CITY PLAN COMMISSION STAFF REPORT

Trails at Ambassador

CD-CPC-2024-00106 Development Plan – Non-Residential

CD-CPC-2024-00130 Rezoning without Plan

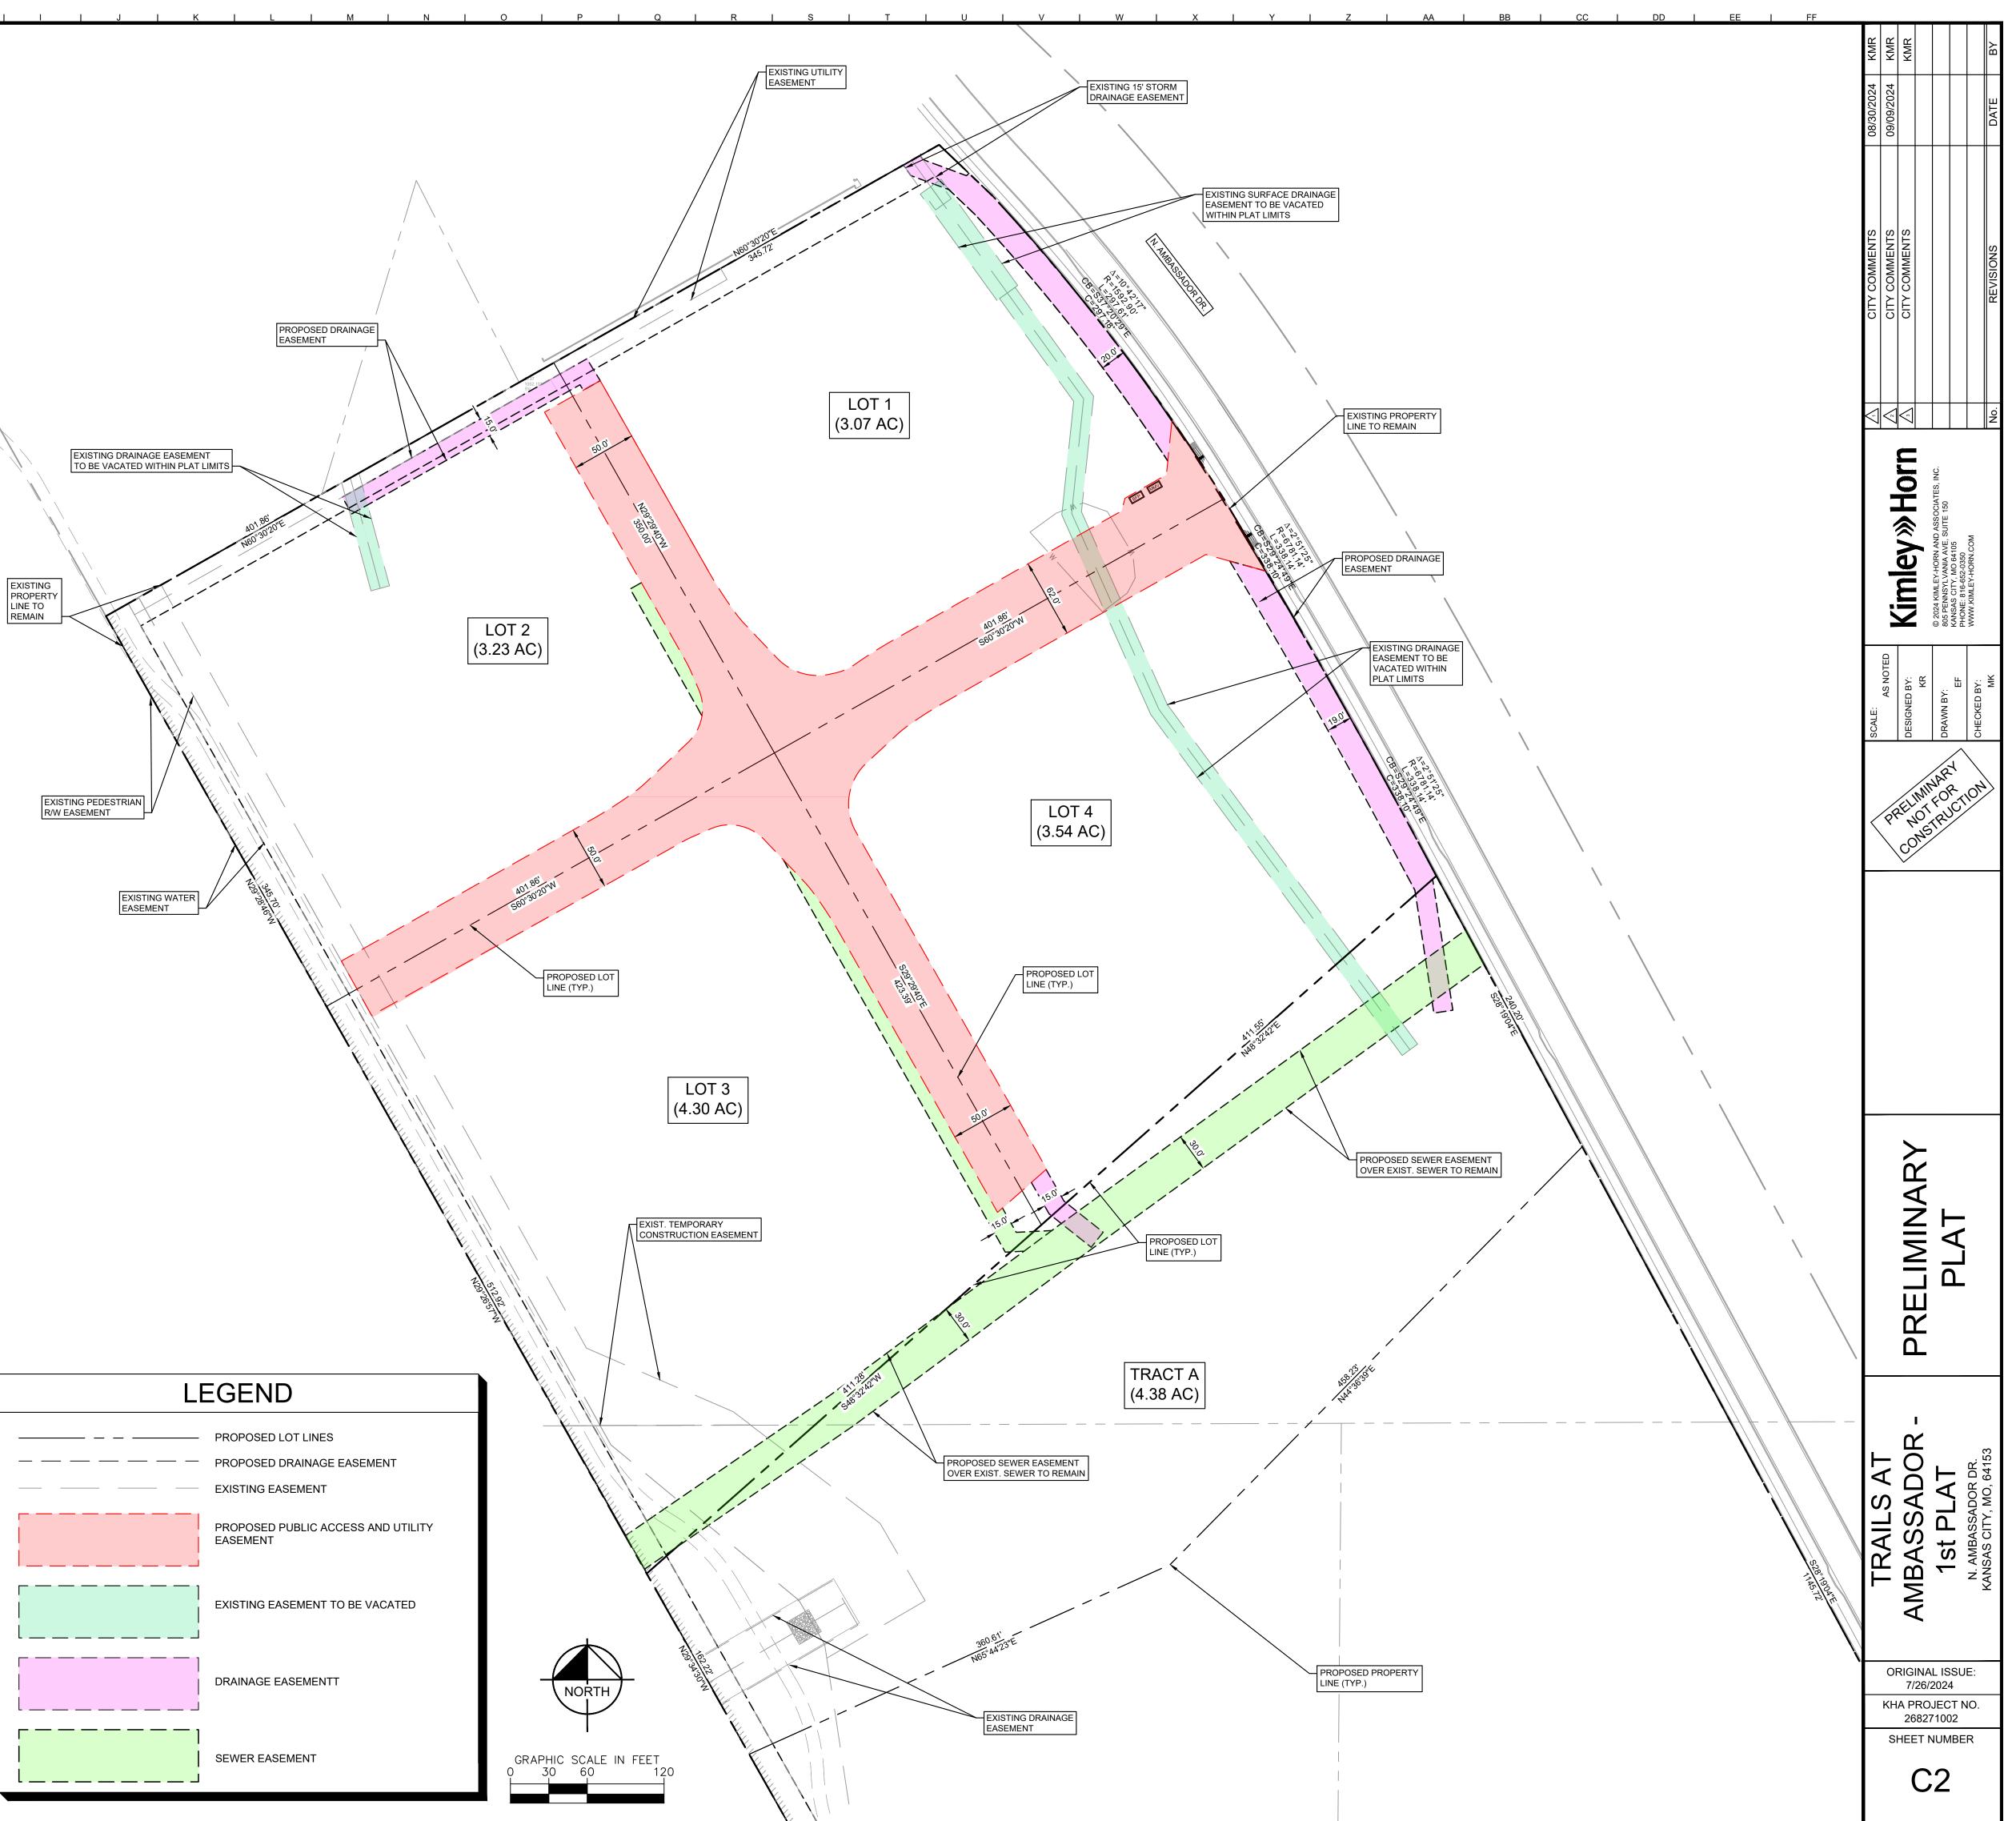
The applicant is not encroaching upon the I-29 trail easement located on the far western perimeter of the site. The applicant will need to submit a revised preliminary plat to show where the Special Rapid Transit Corridor easement will be located along North Ambassador Drive. The applicant is still coordinating with KC Water on the final utility plan for the proposed development. *indicates adjustment/deviation

The applicant is seeking a 5 foot height deviation to increase the maximum height to 60'. The applicant shall also resubmit the preliminary plat prior to ordinance request to show the Special Rapid Transit Corridor easement along North Ambassador Drive.

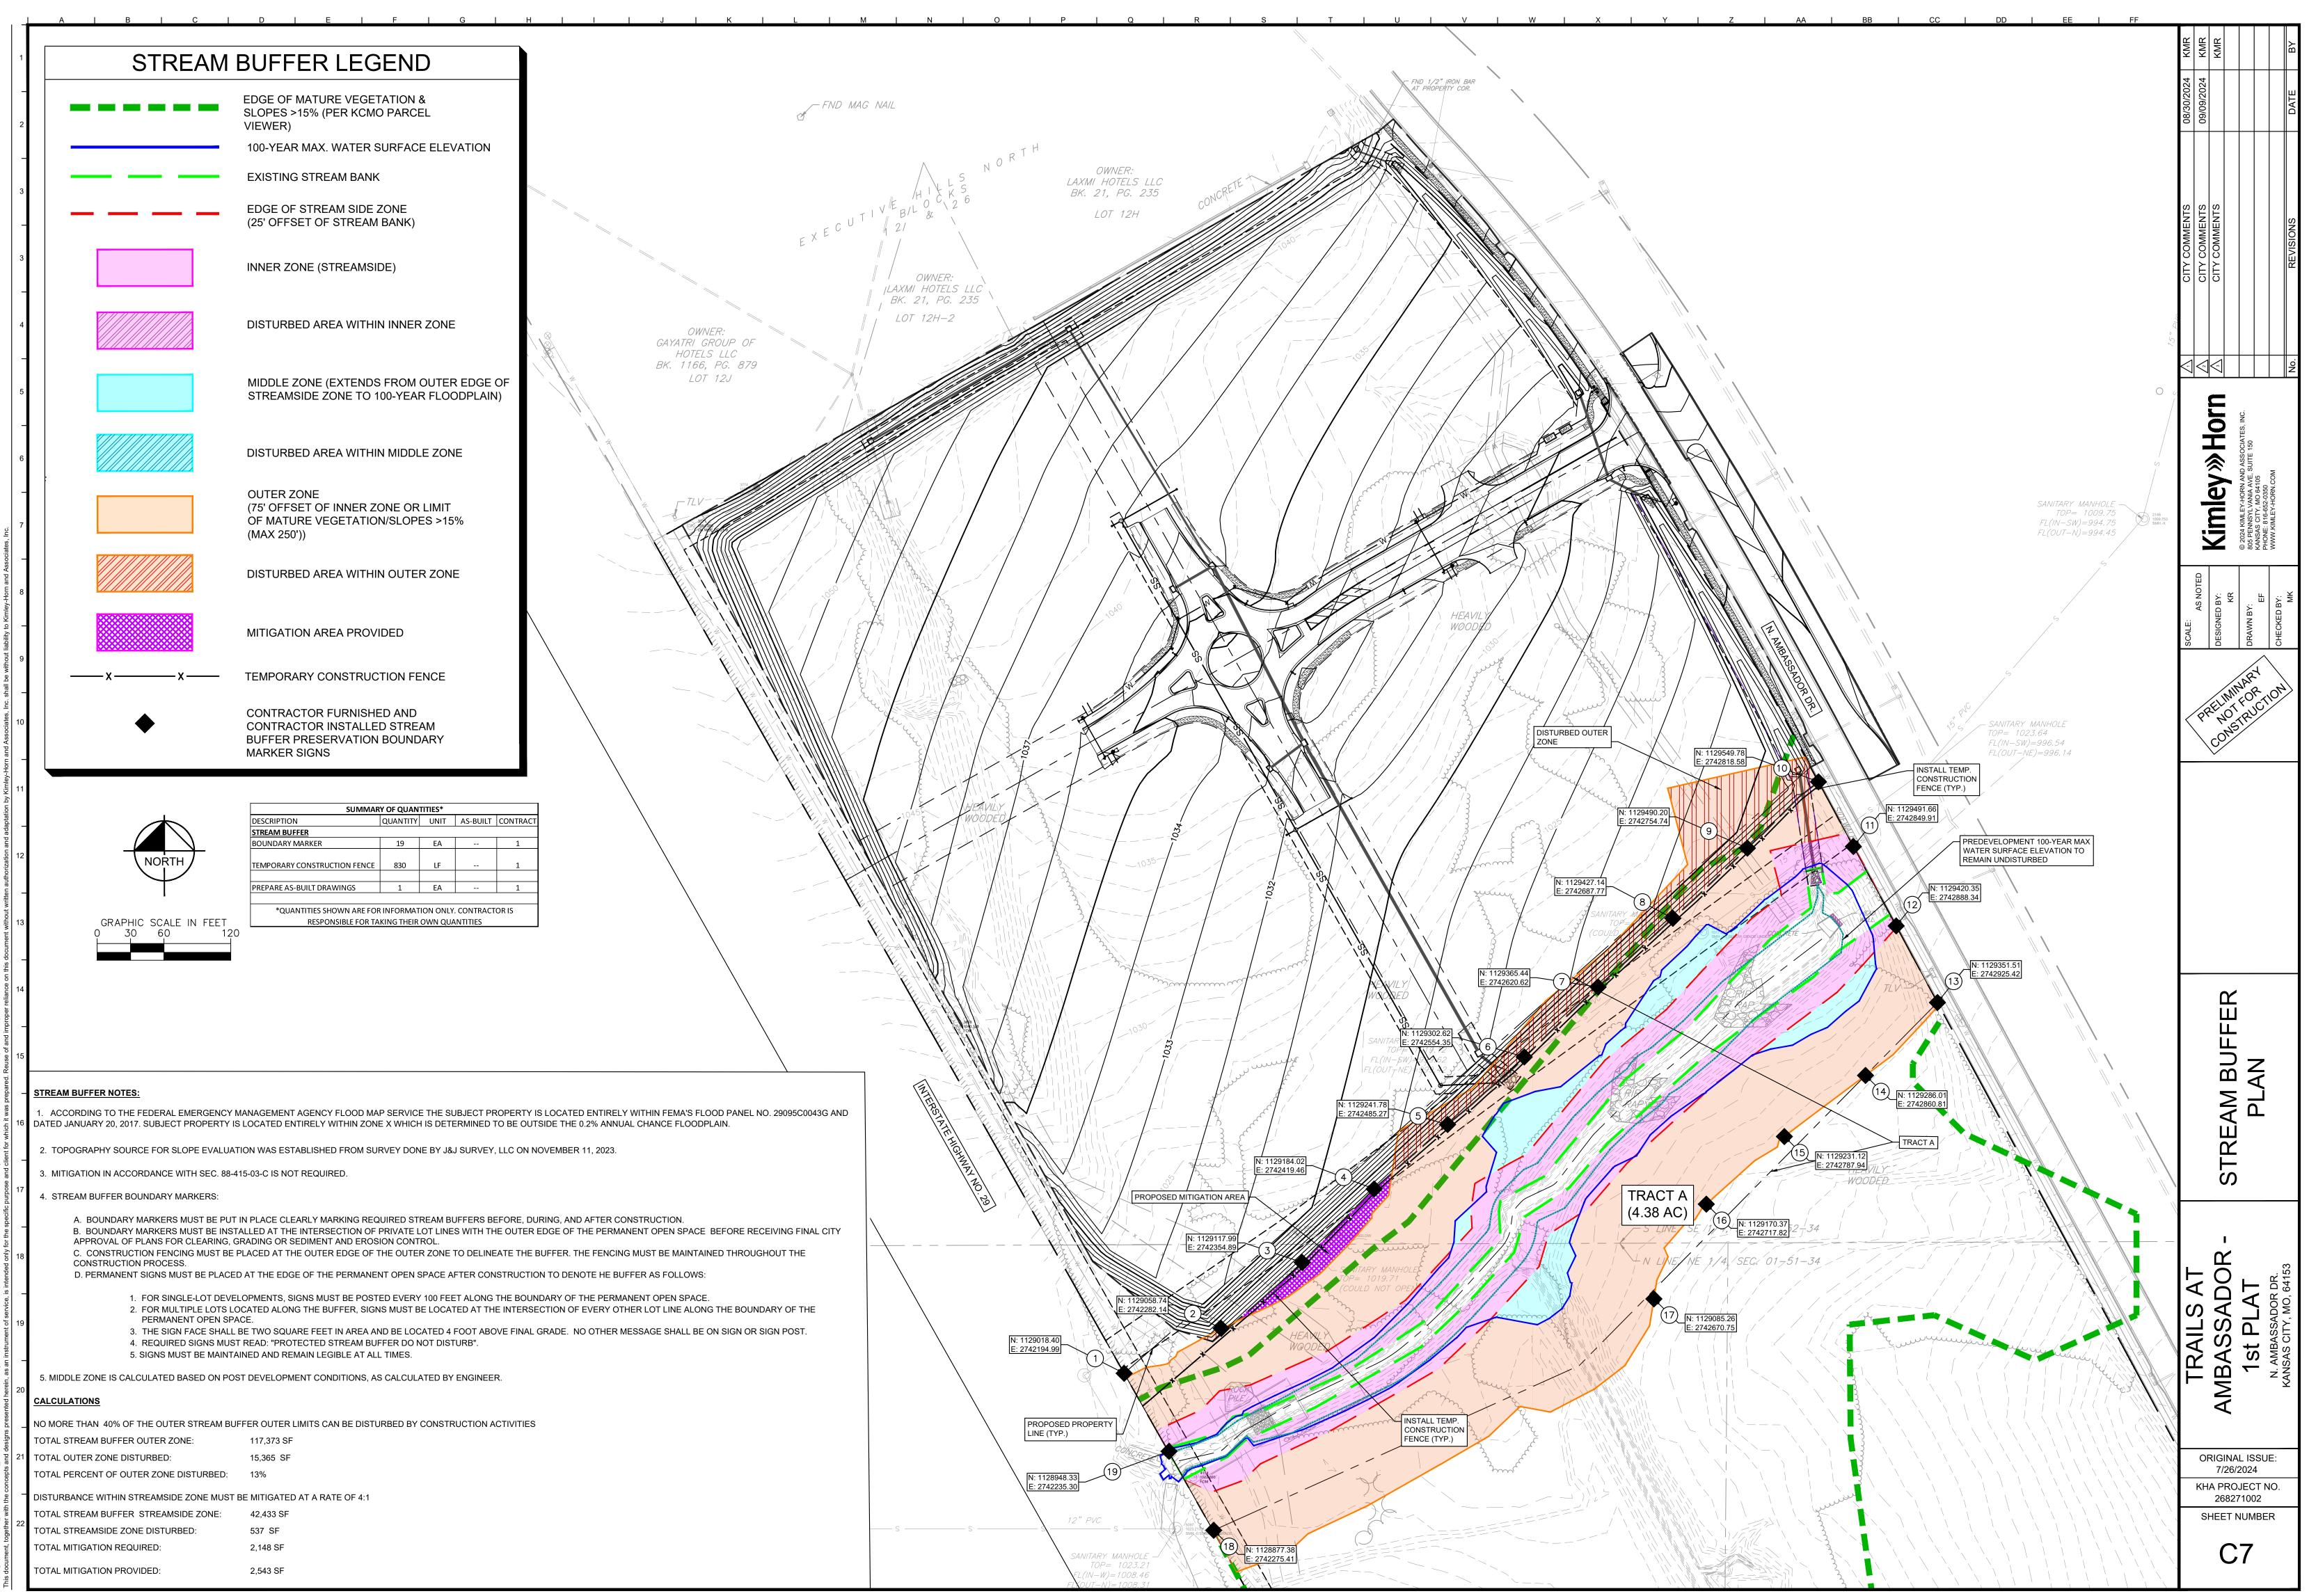
The applicant will be removing over four acres of trees and is not required to provide any mitigation as there is an existing stream buffer.
